IN THE MATTER of Ashbourne (FTAA-2507-1087)

**STATEMENT OF EVIDENCE OF DUNCAN BRETT WALKER ON BEHALF OF
THE MATAMATA-PIAKO DISTRICT COUNCIL**

HIGHLY PRODUCTIVE LAND

Review of NPS-HPL
assessment for
Ashbourne Project (FTAA
2507-1087)

Figure 3: Distribution of LUC classes and soils across assessment area (source: Landsystems report)

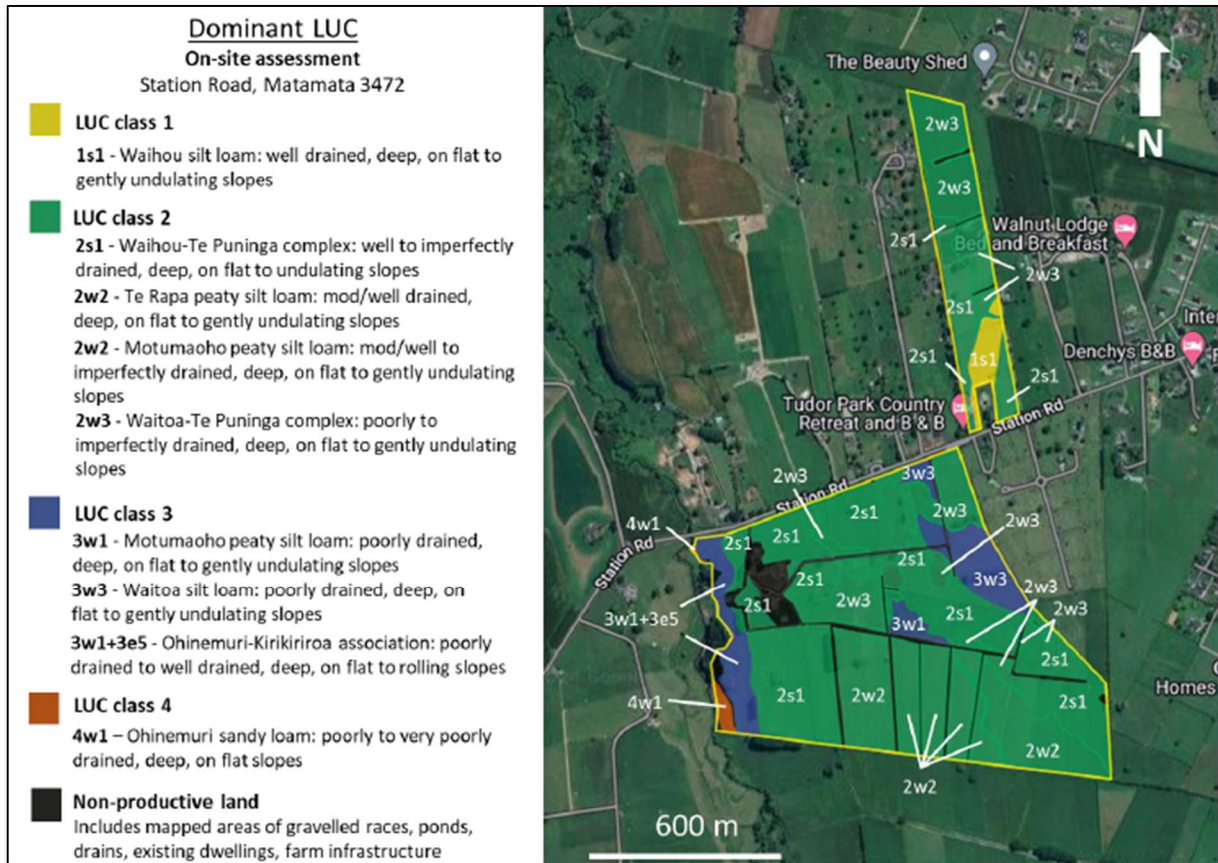
3.6 Overall, the property-scale LUC mapping identified discrepancies in the extent of LUC class 2 and 3 land compared to the regional-scale maps, as well as in the drainage characteristics across the assessment area. Key observations included the following:

- Approximately 2 percent of the assessment area was LUC Class 1 land, which does not appear in the regional-scale maps.
- Of the LUC Class 2 land mapped at the regional level, there was a greater proportion of imperfectly to poorly drained 2w3 land and only 38 percent was imperfectly to well drained LUC 2s1.
- Around 20 percent of the assessment area was moderately well to imperfectly drained LUC 2w2.
- Approximately 10 percent of the assessment area was LUC Class 3 land (regionally mapped as less than 1 percent).
- Around 1 percent of the assessment area comprises LUC Class 4 land, which is not considered to be HPL.
- Around 7 percent of the entire assessment area comprises non-productive/modified land that is not available for primary production.

- 3.8 The report concludes that, as all soils within the assessment area are deep (greater than 1m) and experience a mild climate, the primary limitations for productive use are soil drainage (wetness) and slope class (erosion). We agree with this interpretation.

- 3.9 The report further identifies the suitability of individual LUC units (shown in Figure 3) for a range of productive uses. Considering the drainage and slope characteristics of the assessment area, the report concludes that the following productive uses would be suitable for each LUC unit:

Figure 6: Scheme plan showing proposed subdivision lot layout (source: Volume 2 – AEE Vacant Lot Subdivision)

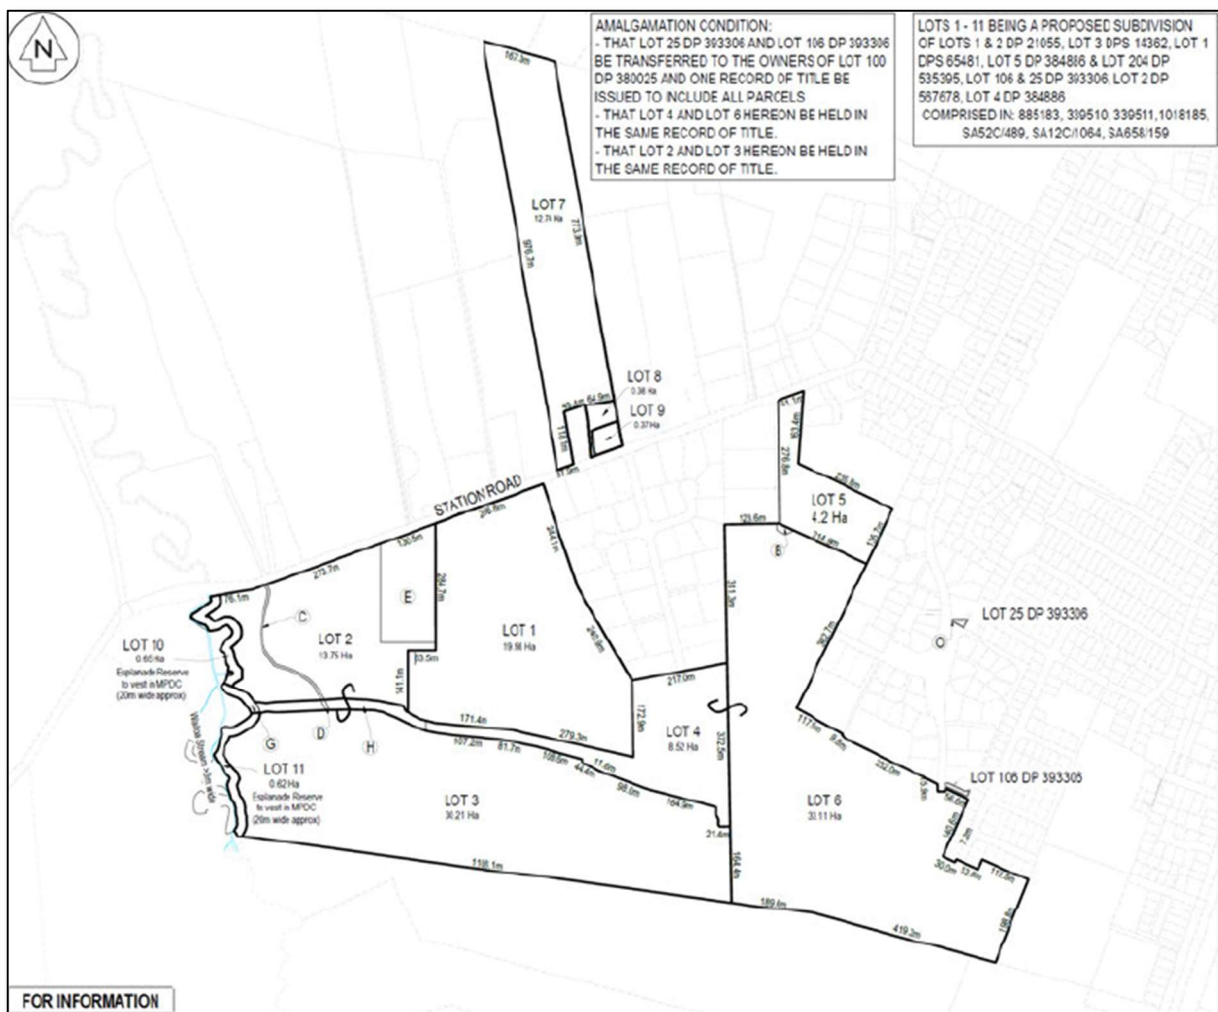
4.2.3 Volume 2, Section 6.2.1 acknowledges that *"the proposed subdivision to create lots 8 and 9 is not consistent with the NPS-HPL,"* but notes that *"the proposed subdivision design retains an appropriately sized balance lot (Lot 7) to support low-intensity uses."* However, it is not clear on what basis the conclusion regarding Lots 8 and 9 has been reached, or whether this assessment relates specifically to Clause 3.8, or instead reflects a broader non-compliance with the NPS-HPL.

4.2.4 In relation to the vacant lot subdivision, Section 6.2.1 of Volume 2 states that *"Clause 3.8 of the NPS-HPL is not applicable as the matters identified in 3.8(1)(a)–(c) do not apply to the proposed subdivision"*. In our view, Clause 3.8 is applicable to the proposed vacant lot subdivision. While the subdivision itself may, if considered in isolation, be capable of retaining the productive capacity of the land over the long term, it forms part of a wider development proposal that would render a significant proportion of the site's HPL inaccessible to land-based primary production. When considered in this broader context, it is unlikely that Clause 3.8 of the NPS-HPL can be fully satisfied.

Figure 7: Approximate location of site (yellow marker) within a larger, contiguous area comprising LUC 1 (dark green), LUC 2 (green) and LUC 3 (light green) land. Source: Our Environment².

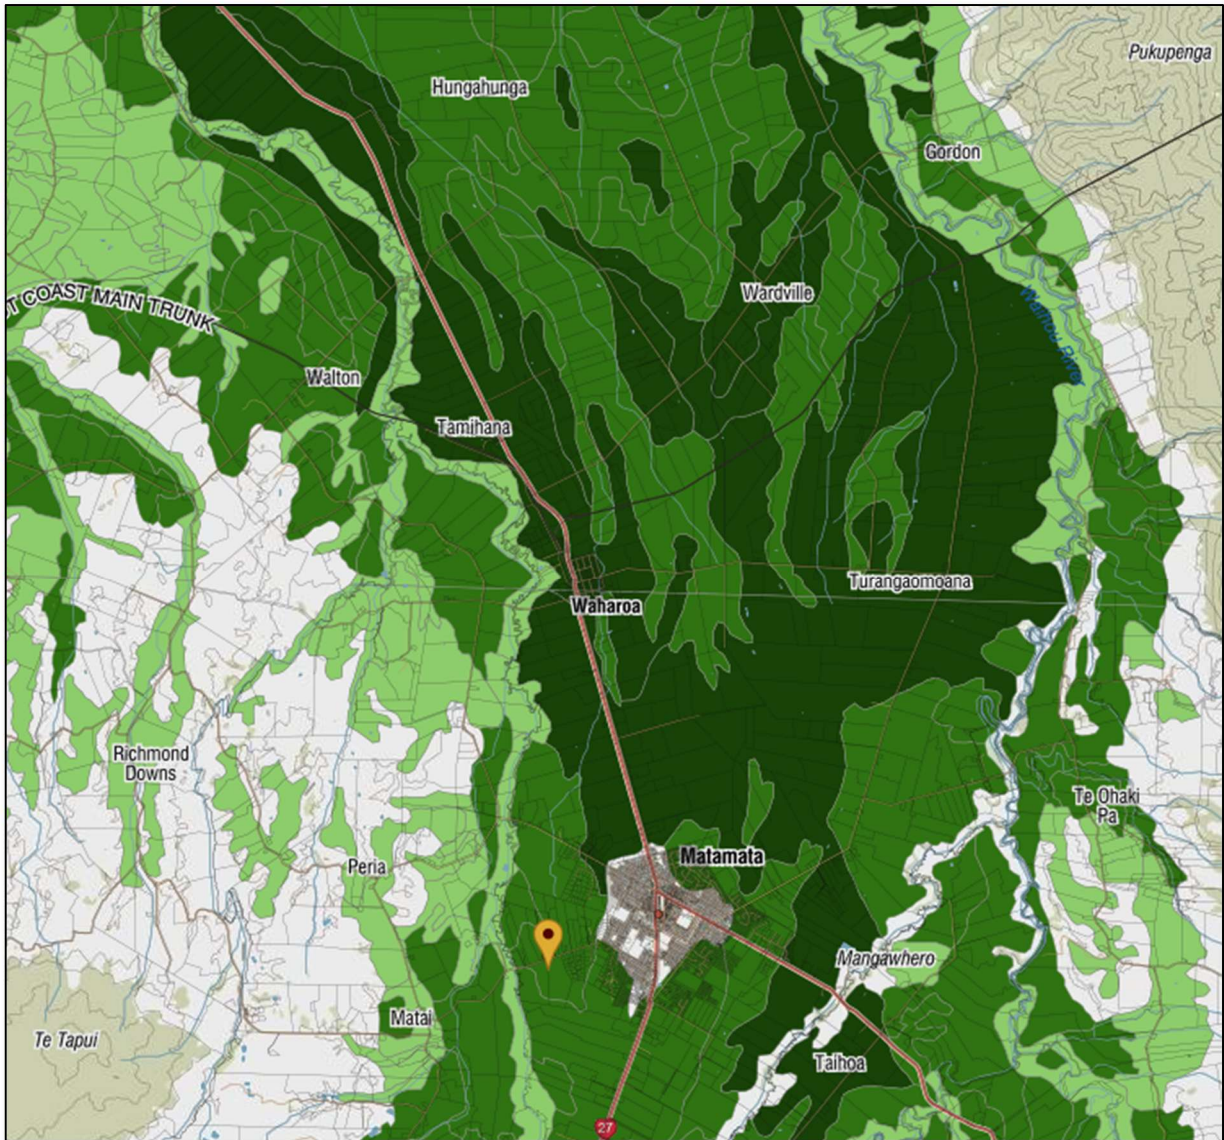
- 4.4.8 Furthermore, the site remains within a much larger and geographically cohesive area of highly productive land extending from south of Matamata through to the Hauraki Plains (see Figure 7).
